SUBJECT: MASSACHUSETTS INSTITUTE OF TECHNOLOGY – ISSUANCE OF
AMENDMENT NO. 42 TO RENEWED FACILITY OPERATING LICENSE
NO. R-37 FOR THE MASSACHUSETTS INSTITUTE OF TECHNOLOGY
RESEARCH REACTOR REGARDING THE NUCLEAR SAFETY SYSTEM
DIGITAL UPGRADE (EPID NO. L-2016-LLA-0003)

1. Amendment No. 42 to Renewed Facility
Operating License No. R-37
2. Safety Evaluation

Figure 1 – NSS Block Diagram

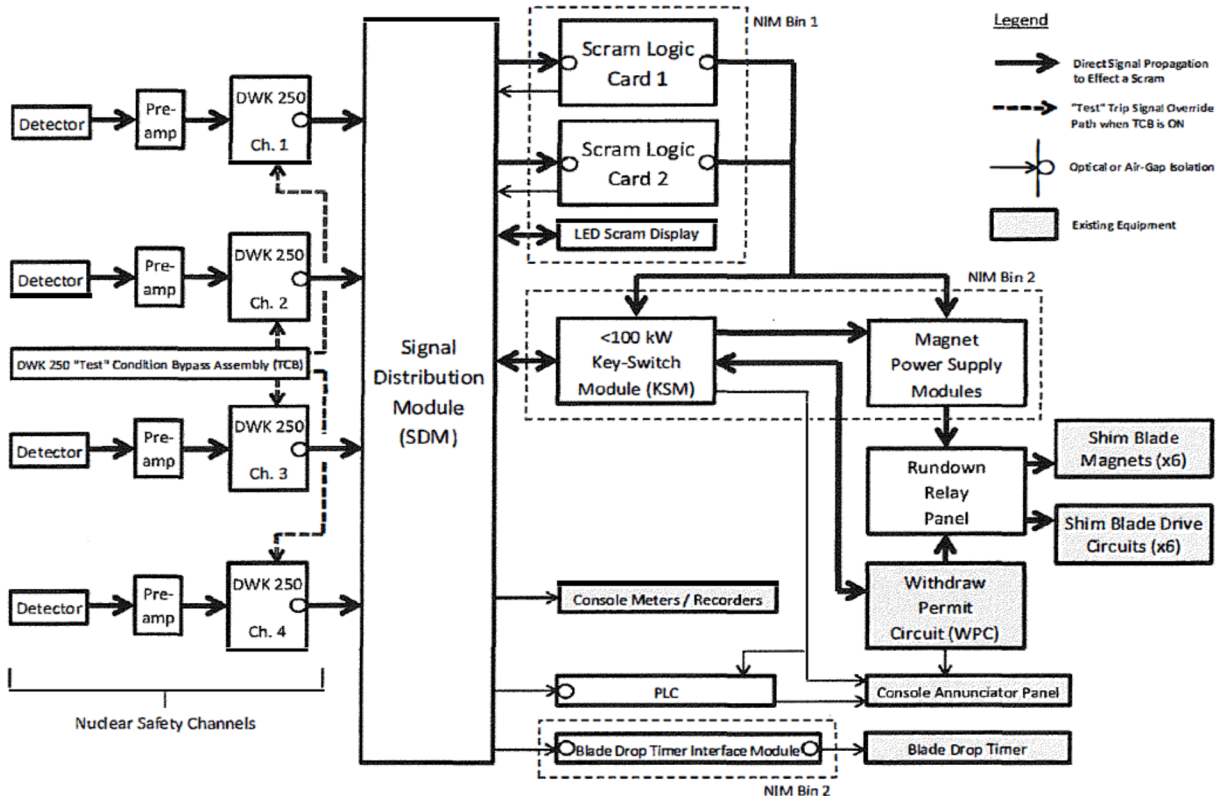
The current NSS monitors both the reactor period and the reactor power level and includes associated dedicated electronics. Channels Nos. 1-3 monitor reactor period, and Channels Nos. 4-6 monitor reactor power level. All six channels provide indication to the operator console. The proposed NSS will replace the current six channels with four independent neutron flux monitoring channels that are identical to each other (new Channel Nos. 1-4). Section 3.2.1 of this SE provides additional information on the operation of the neutron channels.

The DWK 250 initiates a trip signal when any of the neutron channels reaches the trip setpoint value. Trip signals from any two different neutron channels are necessary to generate a reactor scram. This scram signal will travel from the DWK 250s through the SDM, SLCs, KSM, WPC, magnet power supply system, and rundown relay circuit. In this manner, a scram signal is processed and transmitted to remove magnet current and drop the shim blades by gravity into the reactor core, thereby shutting down the reactor. Reference 15, Enclosure D, shows all NSS components and how they are interconnected. Figure 1 (reproduced from Figure 1 of Ref. 15) contains a block diagram of the NSS and associated integrated support modules. This figure identifies the proposed new components and existing components.

Figure 2: Fission Chamber Horizontal Orientation

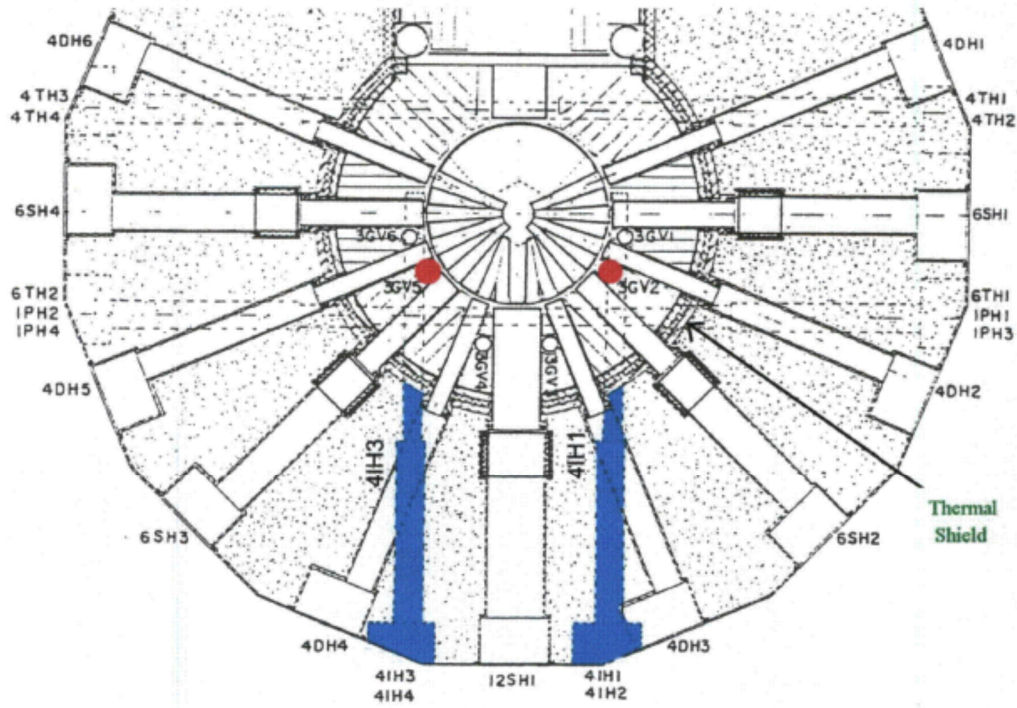
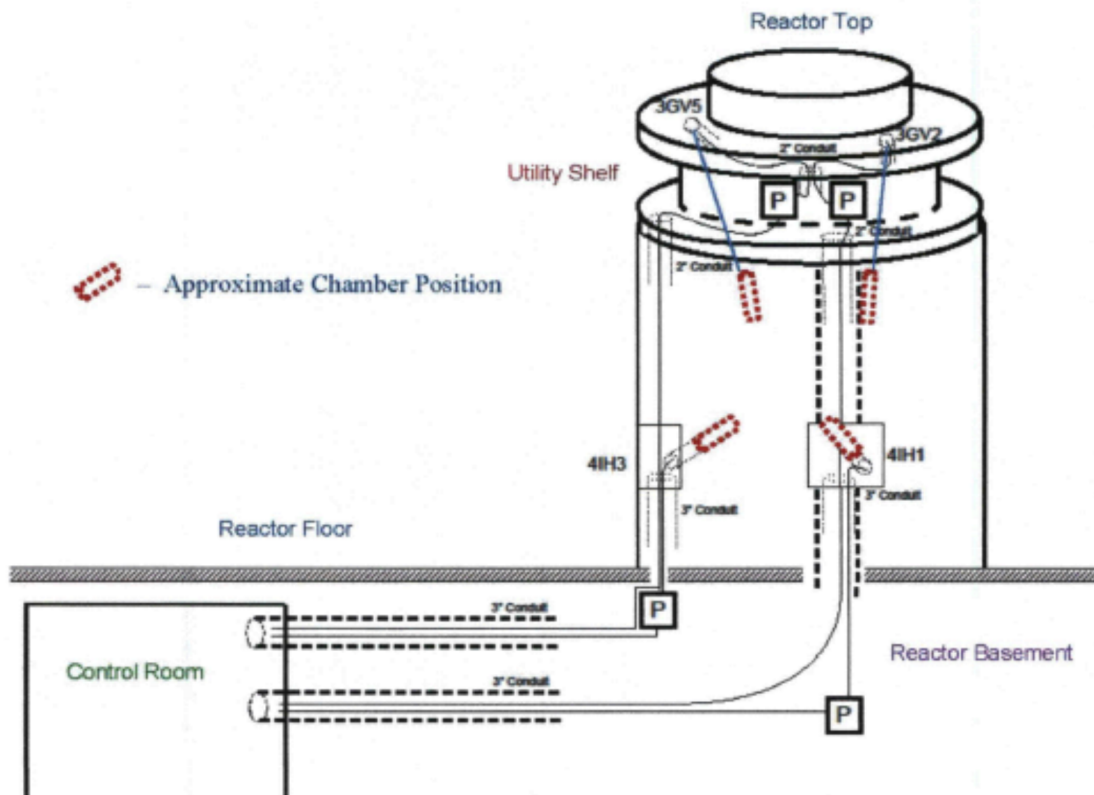
Appendix A and Section 7.4.1 of the LAR describe the installation of the fission chamber detectors for Channels 1 through 4. Each fission chamber is installed in a physically separated instrument port or thimble, embedded within the reactor shielding in a distributed arrangement around the reactor core. MIT selected these locations to maximize independence from each other and reactor experiments, optimize spatial symmetry, allow accessibility, and provide redundancy. The fission chambers do not interfere with each other and are positioned to have minimum interference from reactor experiments. Location of the channels is illustrated in Appendix A of the LAR. In addition, Appendix A describes the results of measurements for the neutron flux distribution for each port (channel). See Figures 2 and 3 below for a drawing of the locations of the fission chambers.

Based on its review of the information provided, the NRC staff finds that the proposed detector placement and number of NSS channels meets the guidance of ANS/ANSI 15.15 (Ref. 29) to provide the minimum number and locations of detectors sufficient to provide the spatial independence required for continuous and independent indication of the neutron flux from subcritical source multiplication level through the licensed maximum power. The NRC staff finds that the NSS should give reliable reactor power level and rate-of-change information from the detectors and channels that directly monitor the neutron flux consistent with the guidance of IEEE standard 603 (Ref. 25), for those monitored parameters that have a spatial dependence (that is, where the parameter varies as a function of position in a particular region), to provide the minimum number and locations of detectors required for the TS 3.2.3 period and neutron flux protective actions. Therefore, the NRC staff concludes the location of the fission chamber detectors as identified are adequate for protection of the reactor.

Figure 4: Simplified Connection Line Drawing for DWK 250 Logic

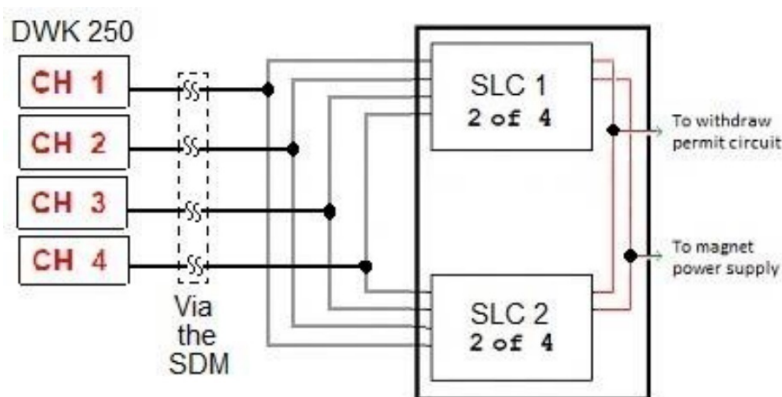
Figure 4 provides a simplified illustration of the connection of the DWK 250s to the SLC. In the figure the designation of CH 1, CH 2, CH 3, and CH 4, represents each of the four DWK 250 channels in the upgraded NSS. The SDM distributes signals between the DWK 250 and the SLC with no signal processing.

The scram signal from any one of the four DWK 250s goes to both SLCs. The SLCs operate independently, such that, if either of the SLCs detects a scram from at least two of the DWK 250s, the SLC will generate a scram signal to relays that deenergize the WPC and magnet power supply, which will in turn scram the reactor by deenergizing the shim blade magnets. The WPC and magnet power supplies require both input signals to be energized for the output to be energized.

The two SLCs are identical logic circuits, built entirely of non-programmable, discrete solid-state components, that provide redundancy for the NSS. Specifically, the trip signals from each of the four DWK 250s are routed to both SLCs, which perform identical logic comparisons for redundancy. Each SLC performs a two-out-of-four logic comparison of the DWK 250 input signals to shut down the reactor. If only one of the four DWK 250 chassis outputs a trip or failure signal, the SLC will not initiate a scram signal, since two are required by the SLC. This prevents a reactor scram due to a false DWK 250 indication from only one channel, and therefore improves system reliability. However, if a second DWK 250 chassis also outputs a trip or failure signal to the SLC (2-of-4), the coincidence logic will complete, and a scram signal is generated by the SLC. Either SLC creating a scram signal will result in an automatic scram (1-of-2 SLCs). If one of the SLCs fails, this will result in a (fail-safe) scram signal. Therefore, two redundant SLCs ensures that a single failure of an SLC will not prevent scrambling the reactor.
